Architectural Commission Report

Meeting Date: Wednesday, April 16, 2014

Subject: **COACH**

327 North Rodeo Drive

① PROPOSED STOREFRONT ELEVATION
SCALE: 1/4" = 1'-0"

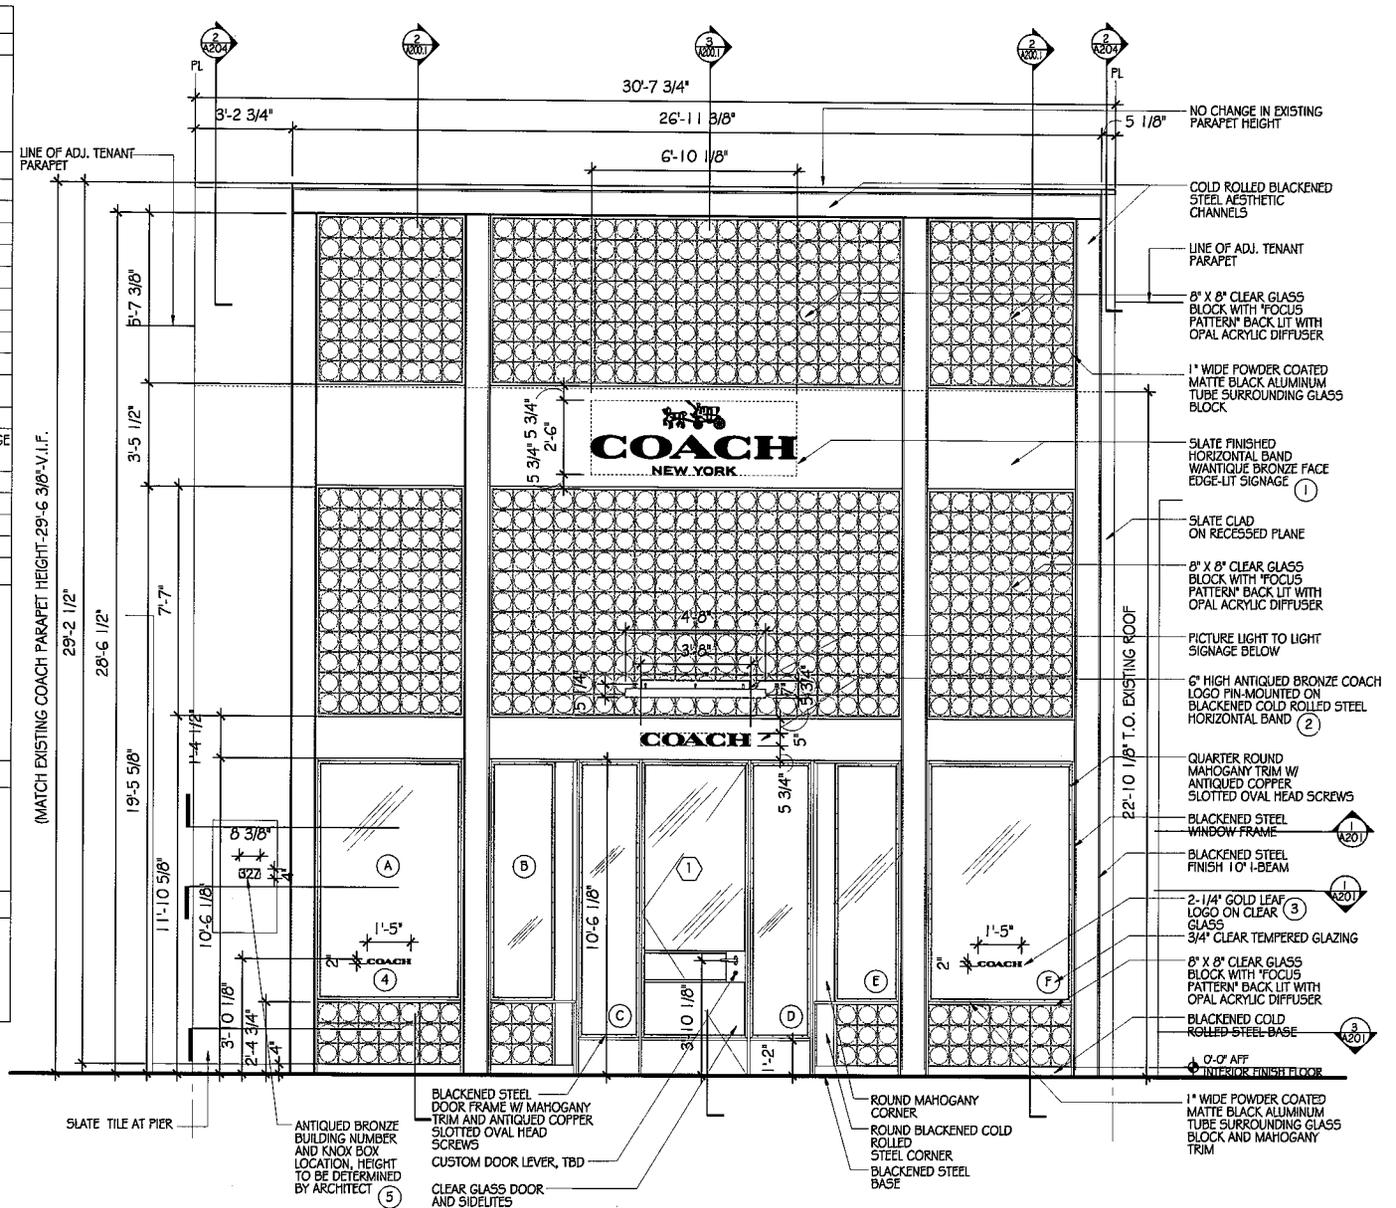
Pursuant to Beverly Hills Municipal Code (BHMC) §10-4-604, the Architectural Commission may approve a sign accommodation to allow multiple business identification signs if the total area of all business identification signs does not exceed the lesser of: 1) 100 square feet; 2) the total business sign area

otherwise permitted by this section, or; 3) 10% of the vertical surface area of that portion of the wall below 20'-0". For this retail tenant, the maximum business identification sign area is 75 SF (based on a storefront width of approximately 37'-6").
